July 2, 2020

RE: Field Modifications to SWL&P PDI Sediment Scope

SUPERIOR WATER, LIGHT & POWER

SEDIMENT INVESTIGATION LOCATIONS  
PRE-DESIGN INVESTIGATION WORK PLAN  
SUPERIOR, WISCONSIN

**FIGURE 1**

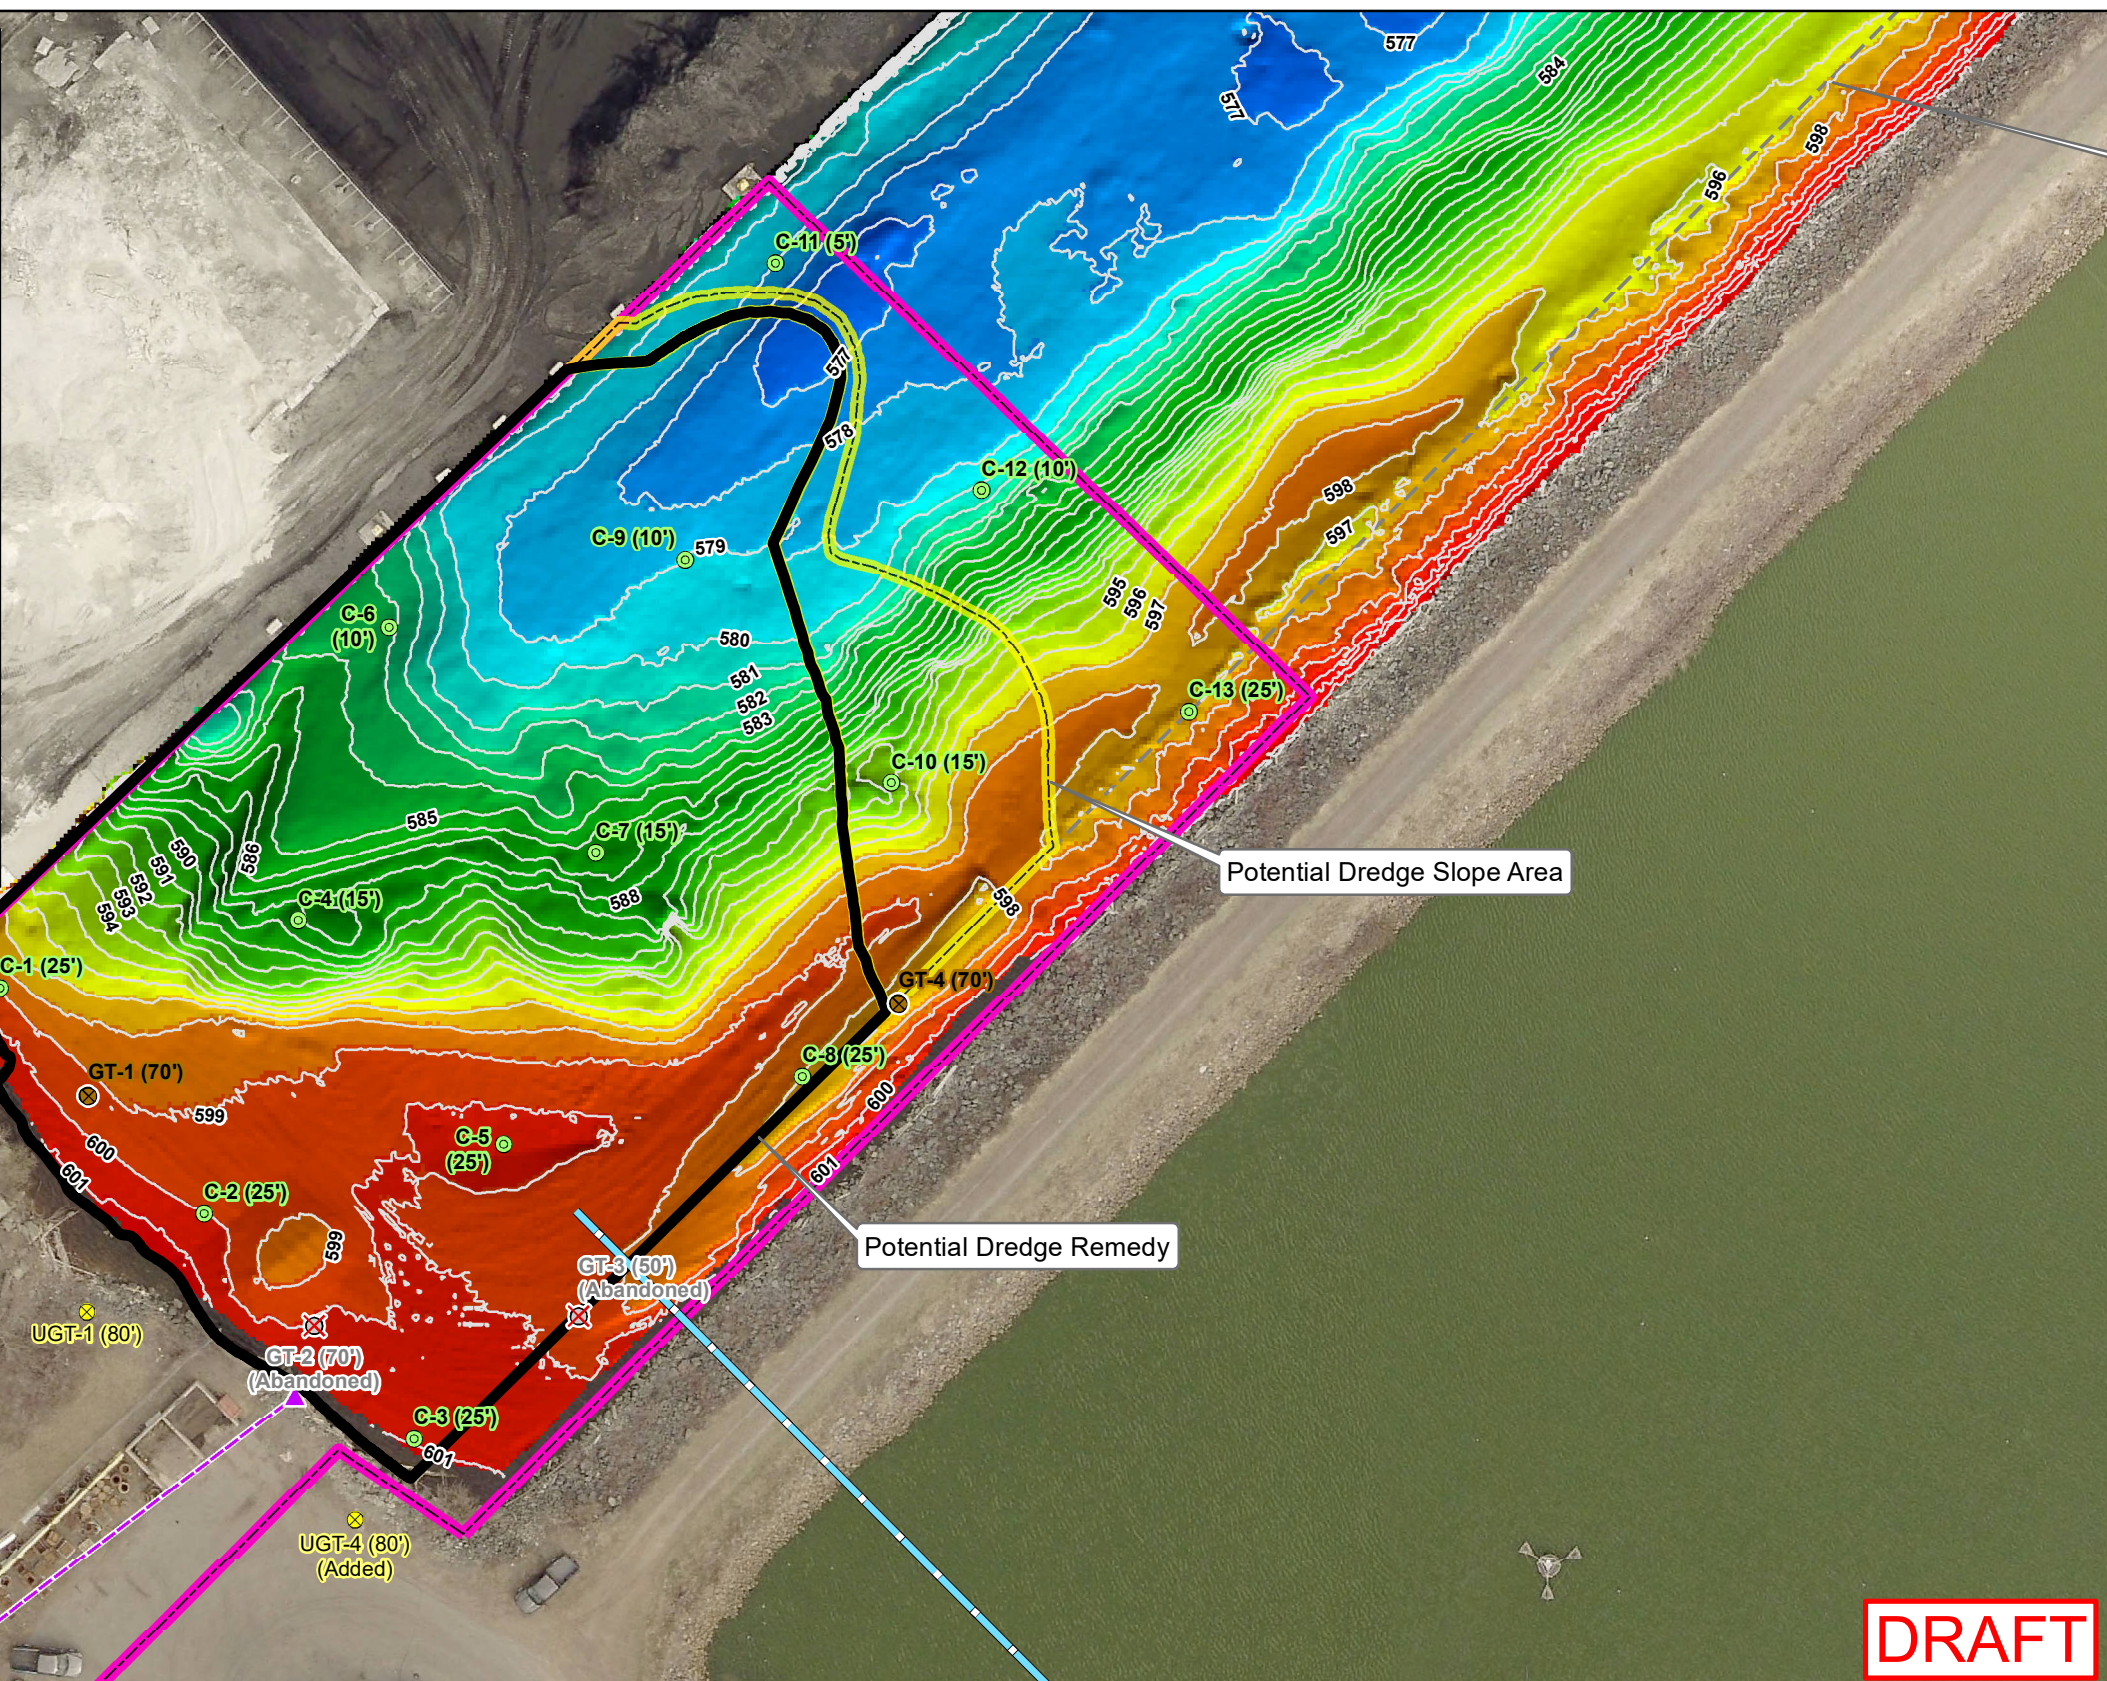
The attached Figure 1 shows draft bathymetry contours as well as the anticipated depths to water for the planned borings. Sample locations with water depths shallower than 3 feet are anticipated to be inaccessible from the barge and will be moved, eliminated, or collected via alternative means. The proposed modifications to the sediment PDI scope are as follows:

- GT-1 will be approached from deep water to get as close to the proposed location as possible. Depending upon field conditions, the boring will be moved out from the head of the slip to an accessible location (it is anticipated that this location will not need to be moved more than 25 feet from target). The data collected from this new location will fulfill the data quality objectives.
- GT-2 will be abandoned and replaced with an upland location (UGT-4 on Figure 1) that is coincident with the on-shore projection of edge of the Waste Water

Treatment Plant (WWTP) armored berm in the back corner of the boat slip. Given the difference in drilling elevations, the boring will be advanced to 80 ft below ground surface (bgs) instead of the planned 70 ft below mudline (bml). The data collected from this new location will fulfill the data quality objectives.

- GT-3 will be removed from the scope of work since there is no location that it can be moved to and provide data that will fulfill the intended purpose.
- GT-4 will be move to a location that is behind the sand bar identified in the bathymetry and as far back (in a southwestern direction, towards the head of the slip) along the WWTP berm as the barge is able to safely maneuver and drill. It may end up close to or beyond C-8 moving towards the head of the slip with the intent to have this boring serve the purpose of both GT-4 and GT-3. Depending upon field observations, this boring may be advanced to 70 ft instead of the planned 50 ft.

To enable collection of environmental sediment cores in the southeastern corner of the boat slip, Coleman Engineering will mobilize a pontoon boat with a geoprobe hammer on it. This should allow us to sample the C-3 and C-2 locations that are inaccessible from the barge. The penetration depth may be limited by the sampling technique, so we may or may not be able to hit the Miller Creek Clay but will go as deep as we are able. Depending upon field conditions and the recovery observed between the drill rig on the barge and the pontoon boat, the other environmental sediment borings will be collected using the more efficient of the two mechanisms.

- C-1, C-5, and C-8 will be approached from deep water to get as close to the proposed location as possible. Depending upon field conditions, the boring may be moved out from shallow water to an accessible location.
- Locations C-4, C-6, C-7, C-9, C-10, C-11, C-12, and C-13 have anticipated water depths ranging from 5 to 25 ft. and are not anticipated to pose a challenge.
